**COMMUNITY DEVELOPMENT DEPARTMENT  
PLANNING DIVISION**

**ADMINISTRATIVE HEARING STAFF REPORT**

Architectural and Site Approval Permit to consider façade and landscape alterations to a bank building (Bank of America) located in the Crossroads Area of the Heart of the City Specific Plan (Application No.: ASA-2020-007; Applicant: Melissa Lee; Location: 20563 Stevens Creek Blvd; APN(s): 326-34-044)

**Figure 2 & 3 – Existing Front (South) & Rear (North) Elevations**

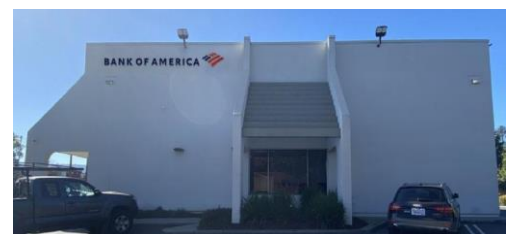
The existing exterior materials of the building are mainly stucco with a terracotta tile roof. The south (front) elevation features a covered arcade with stucco finish. The north (rear) and east (right) side elevations of the building are plain stucco. The west (left) elevation has a stone finish with a covered arcade with stucco columns (See Figures 2-5 below).

**Figure 10 – Landscape Plan**

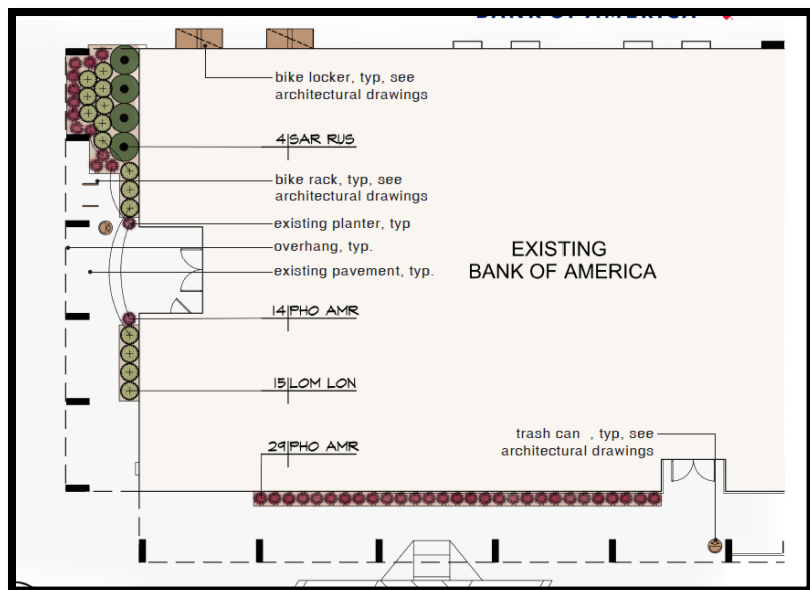
The applicant is proposing to modify approximately 260 square feet of the existing landscape on the west (left) and south (front) elevations of the building by replacing the existing plants along the building with new drought tolerant ground cover (Sheets L1.0 & L1.1, See Figure 10). The project is subject to a Prescriptive Compliance Application pursuant to the Cupertino Municipal Code Landscape Ordinance (Chapter 14.15). The Landscape Ordinance requires the applicant to submit a Water-Efficient Landscape Checklist and finalized landscape and irrigation plans prior to building permit issuance. Additional landscape documentation is required prior to final occupancy in accordance with the Landscape Ordinance.

The proposed landscaping will be compatible with the new design of the building façade. However, Staff has found that the proposed planting plan at the main entrance of the building (south elevation) lacks visual interest. Staff has included a condition of approval for the project requiring the applicant/ property owner provide an assortment of shrub types with various heights and/or color profiles along the south elevation. Incorporating a variety of plantings will improve the visual interest of the façade that is most visible from the public right of way and bring the project into compliance with the Heart of the City Specific Plan landscaping guidelines, which encourages framing building entrances with flowering shrubs or trees.
